FEASIBILITY STUDY FOR INSTALLATION OF UMCS FORT RILEY, KANSAS

ENERGY ENGINEERING ANALYSIS PROGRAM (EEAP)

U.S. ARMY CORPS OF ENGINEERS
KANSAS CITY DISTRICT
KANSAS CITY, MISSOURI

December 1995

FIGURE 2-1. EXISTING EMCS

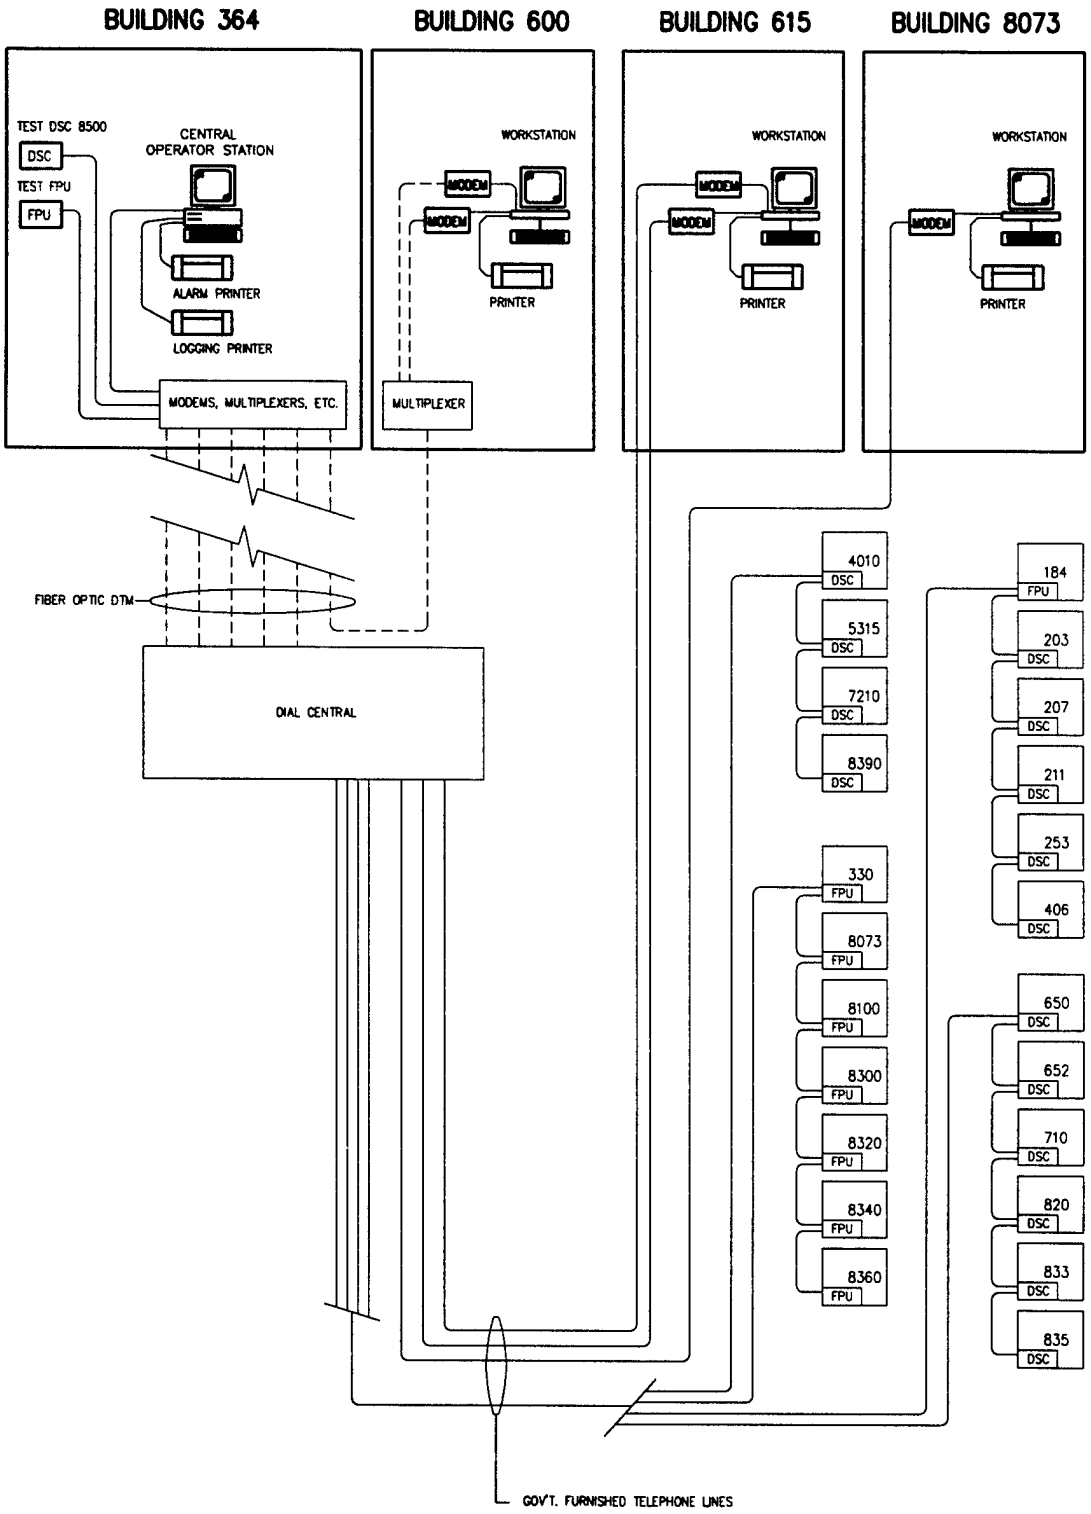
Reference	Item No.	Comments	Action
Vol 1, Sec 2, p 2-15, Fig 2-1	1	Show a FO multiplexer at Bldg 600. FO is direct connected from Bldg 364 to Bldg 600. It is not routed through dial central.	
Vol 1, Fig 2-1, p 2-15	2	Bldg 330 is located on trunk 3 with the 8000 area Bldgs.	
Vol 1, Fig 2-1, p 2-15	3	There are 2 direct connect modems each in Bldgs 600 and 615.	
Vol 1, Fig 2-1, p 2-15	4	There is a test DSC 8500 in Bldg 364.	
Vol 1, Sec 3, p 3-2, Para 3.3	5	Add the following standard report: Energy Savings	
Vol 1, Sec 4, p 4-2, para 4.2	6	New RCUs and ACUs should have a minimum of 10% spare capacity, but not less than two (2) of each of the following: digital output, digital input, analog output, and analog input.	
Vol 1, App D, I/O #3, p D-8	7	We want a Control Relay W/H-O-A on the Small Steam Boilers	
Vol 1	8	Bldgs 650 and 652 have several monitoring and panic points on the existing EMCS system that appear to have been left off of this study (EX. I/O #8, E4-31). Are all existing points on the existing EMCS listed in the study and included in the cost estimate? This project is to replace what is existing and to install new.
